**From:** <Richard.Olsson@ski.se>  
**To:** OWFN\_DO.owf4\_po(RFD)  
**Date:** Thu, Apr 27, 2000 5:21 AM  
**Subject:** VB: Draft Final Technical Study SFP Risks at Decom NPPs

Issued by  
Mats Sjöberg/ Ferenc Müller

Date  
2000-04-05

**Questions/Comments on the NRC "Draft final technical study of spent fuel accidents risk at decommissioning nuclear power plants", 7590-01-P.**

FIGURE 1: Envelope Ground Response Spectra for a (principal) horizontal GM direction, relating to, exceedance frequencies  $10^{-5}$ ,  $10^{-6}$  and  $10^{-7}$  annual events per site and damping ratios 0.005, 0.02, 0.05, 0.07 and 0.10.

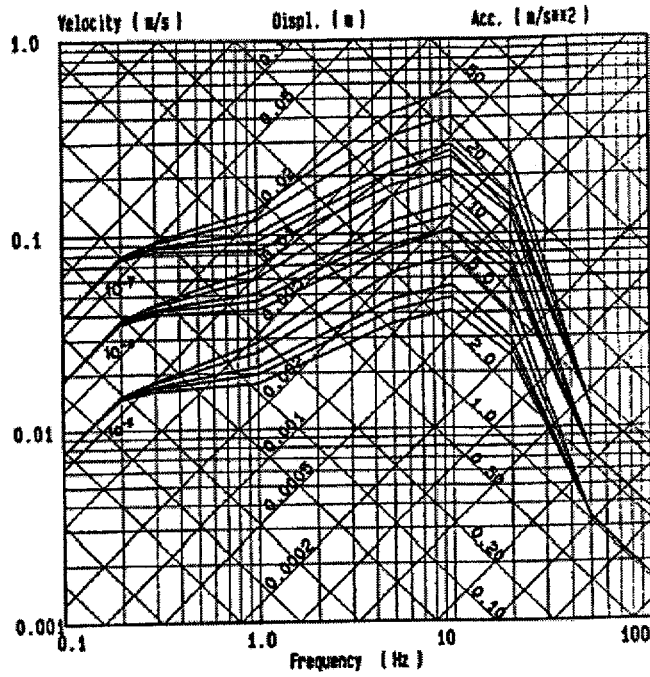
5. An US earthquake response spectra  $10^{-5}$ /year (0.5g) is considered as a  $10^{-7}$  in Sweden. Does this justify exemption from further consideration, due to low yearly frequency for Zr-fire? The SFP at the Swedish plant is calculated with an earthquake 0.1g, see response spectra Figure 1, and found to comply with the Swedish standard design standard (Boverkets Konstruktionsregler 94, BKR94.
